Amendment to the Drawings

REMARKS/ARGUMENTS

Fig 4

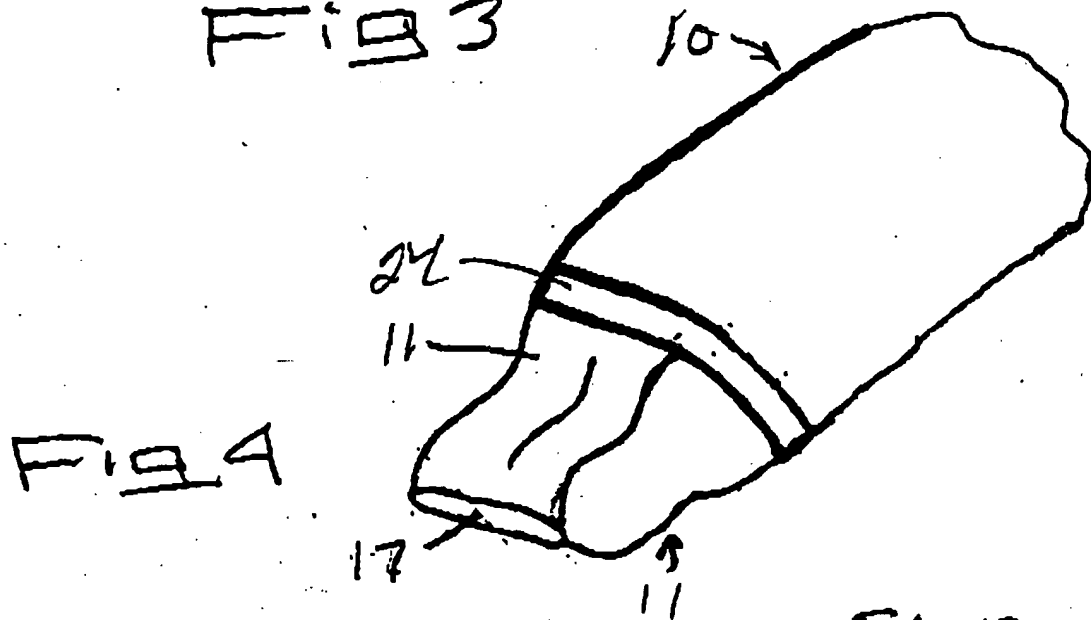
Applicant traverses the objections that: 1) the angle of the device in Figure 4 makes it difficult to determine the disposition of spreader 17 with respect to the nozzle 11; 2) and, Figure 29 should be broken into two individual drawing portions. Figure 4 is an embodiment in accordance with the inventor’s invention. Applicant submits that any requirement for the inventor to change this drawing would be unacceptable. Moreover, Figure 29 depicts a spreader with a cap, attached to a container. Applicant respectfully asserts that there is no need to separate the attached items in Figure 29 and include them in separate figures.

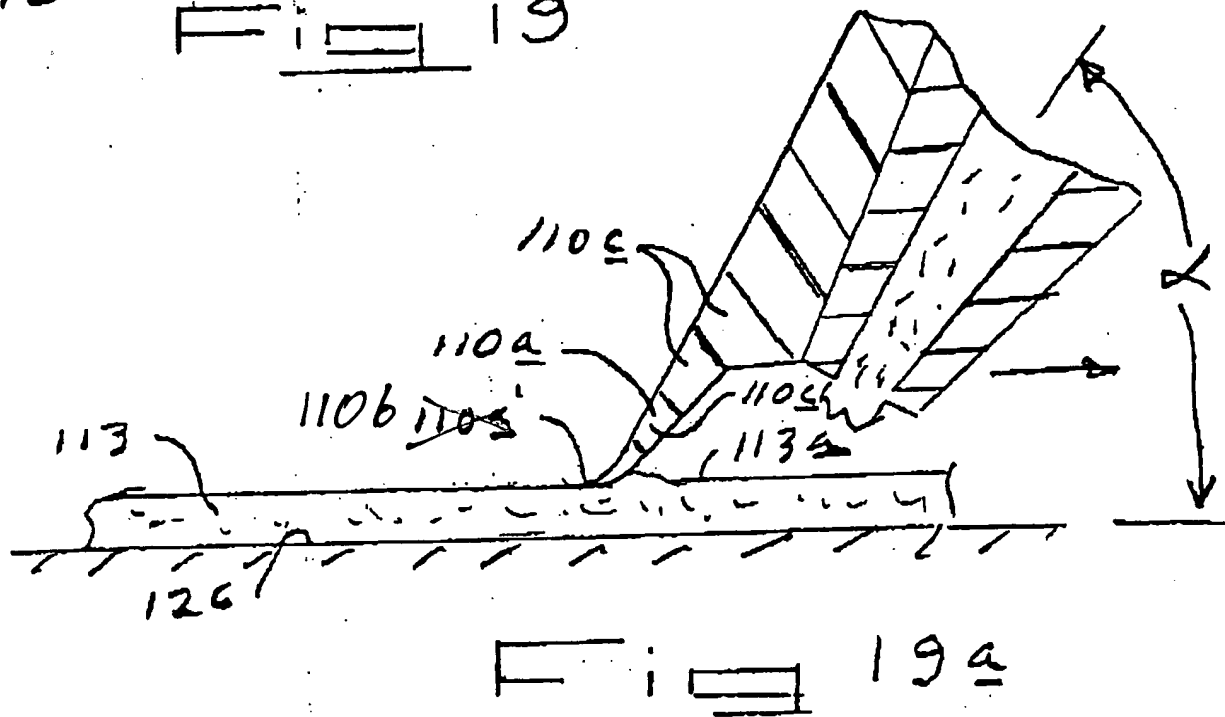
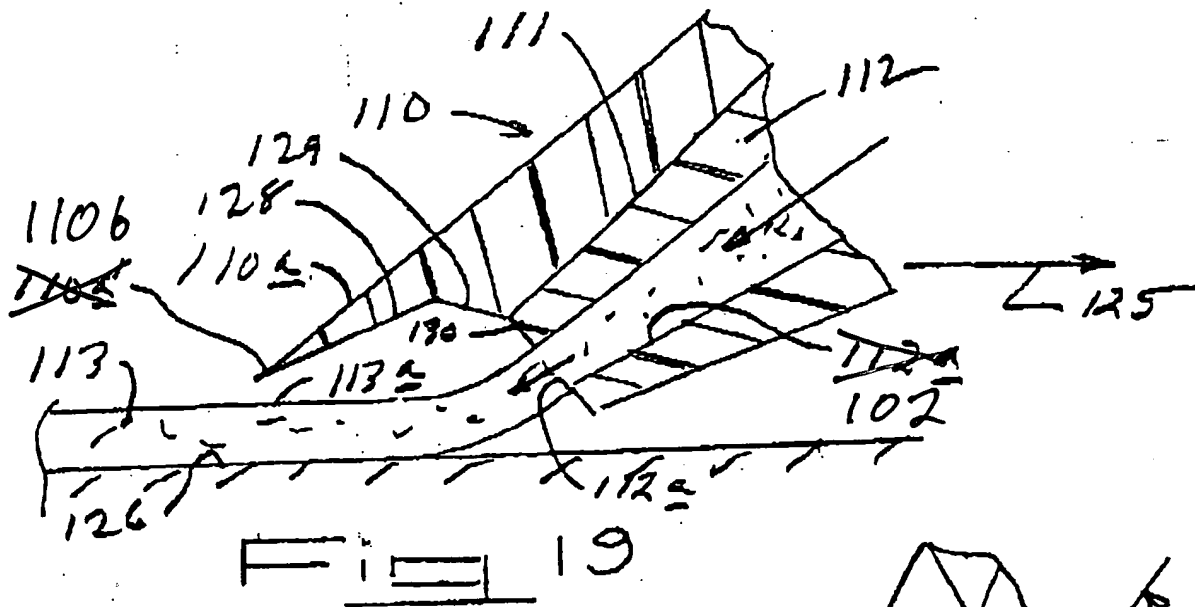
In response to the objections to the drawings, Applicant has amended the specification and submits herewith proposed replacements sheets wherein Figures 1, 2, 5, 6, 8, 15, 18, 19, 19a, 20, 24, 25, 30 and 31 wherein proposed corrections have been made. In particular: Figures 1 and 2 have been modified to include reference number 21; Figure 5 has been modified to remove reference number 32a; Figure 6 has been modified to correct the position of the lead line for reference number 189, remove an unnecessary line, and to depict threading; Figure 8 has been modified to replace reference number "34" with "87"; Figure 15 has been modified to make reference number "61a" clear; Figure 18 has been modified to show how the views in the figure interrelate; Figures 19 and 19a have been modified to replace reference number 110a' with 110b;

Figure 19 has been modified to replace the incorrect use of reference number “112a” with “102”; Figure 20 has been modified to replace the incorrect use of reference number “17” with “17a”; Figure 22A has been modified to include reference number/letters “313” and “P”; Figure 22B has been modified to include reference “P”; Figure 23 has been modified to include reference number 415 and a bracket to show a single entity; Figure 24 has been modified to include reference “F”; Figure 25 has been modified to include a bracket to show a single entity; Figure 26 has been modified to include reference number 601 and a bracket to show a single entity; Figure 28a has been amended to include reference number 807; Figure 28b has been amended to include a bracket to show a single entity; Figure 30 has been amended to include reference number “1004” and to show how the views in the figure interrelate; and, Figure 31 has been amended to move the location of “FIG 31”. The corrections do not add any new matter and approval of the proposed changes is respectfully requested.

FIGURE 23

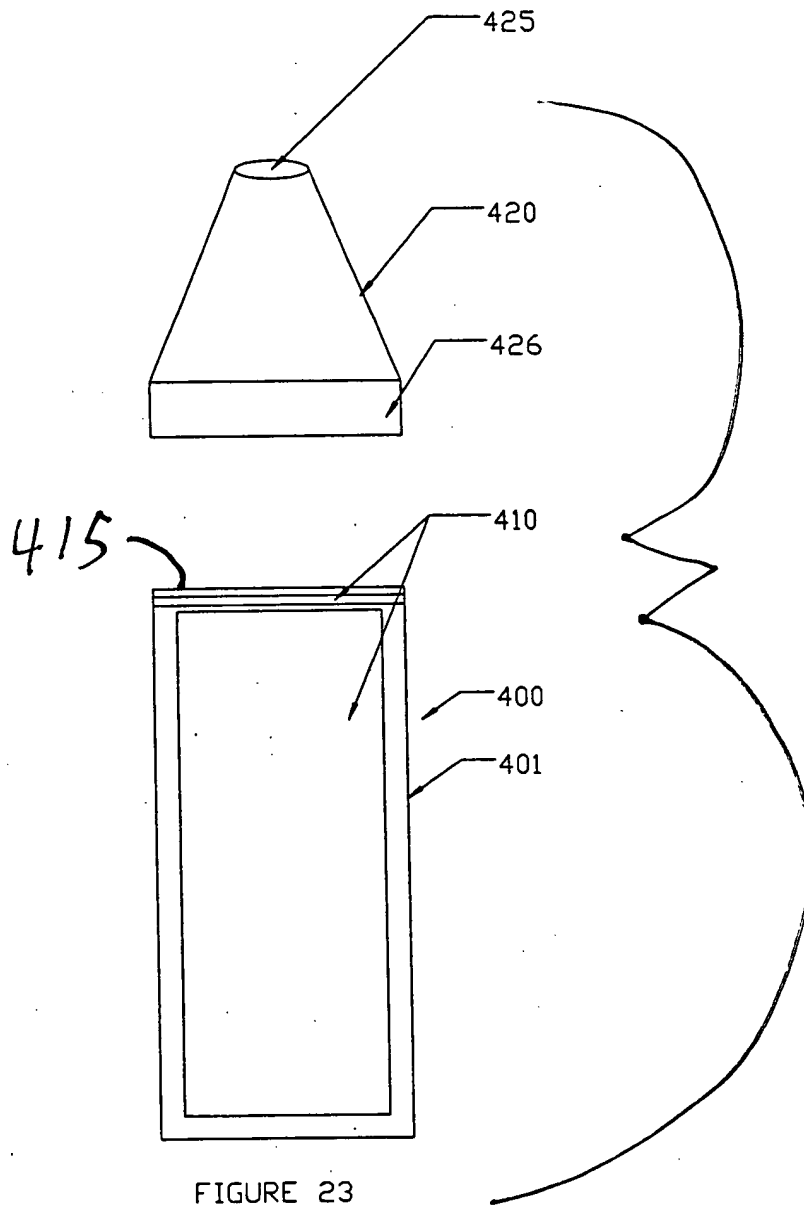
With regard to the newly added reference numbers, reference number 415 within Figure 23 is included in the specification by replacing reference number 426 on page 16, line 22, of the originally filed specification. Reference number 601 is include in the specification by added the statement that the spreader “is attachable to container 601.”
